DRAFT Urban Design Appendix

Healthpeak’s Final Development Plan (“FDP”) represents a critical step toward realizing the City’s long-term planning and design goals for the Alewife Quadrangle: it establishes a connective street network and a path to realize the bridge across the Fitchburg Rail Line, creates new open spaces and neighborhood uses throughout the district, and provides much-needed space for a future municipal facility.

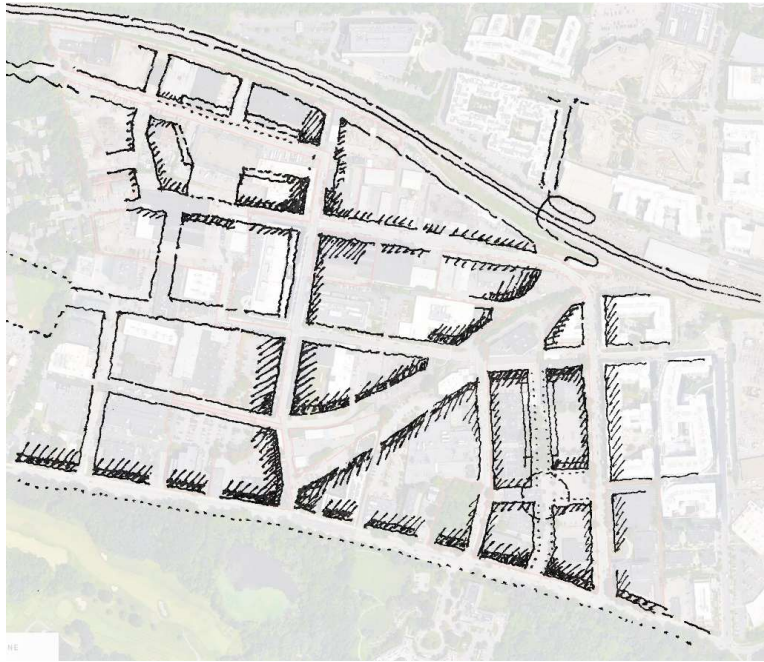
As noted in the Conditions for Design Review, staff recommend that some of the FDP's drawings be updated to more explicitly convey a vision of the PUD's public realm:

- An updated "Massing Strategy" plan (Volume 2 figure 1B.1)
- Updated "Block Massing Diagrams" (Volume 2 figure 1L.6a and following)
- Updated overall aerial views of the PUD. (Volume 1 figures 2.9a, 2.9b, 2.9c, and 2.9d, and Volume 2 figures 1B.4 and 1B.5)

The updated Massing Strategy plan should be a graphically clear and simple drawing that conveys the organization of the PUD's public realm by depicting its interconnected network of public spaces. It should simplify the "Massing Strategy" Plan (the Final Development Plan's Volume 2, Figure 1B.1), to a figure/ground diagram that emphasizes the open spaces of the PUD's public realm—its streets, parks, and other public spaces—in contrast to the relative solidity of its urban blocks.

The plan should emphasize the critical edges of the district's most important public spaces by indicating the locations of the building facades that will frame them. It should indicate opportunities for architectural elements that will serve as landmarks and/or that will articulate thresholds between those spaces and mark significant places of arrival. To focus on the essential organization of the PUD's public realm, it should abstract out the footprints of individual buildings and the details of the proposed landscape design and street system.
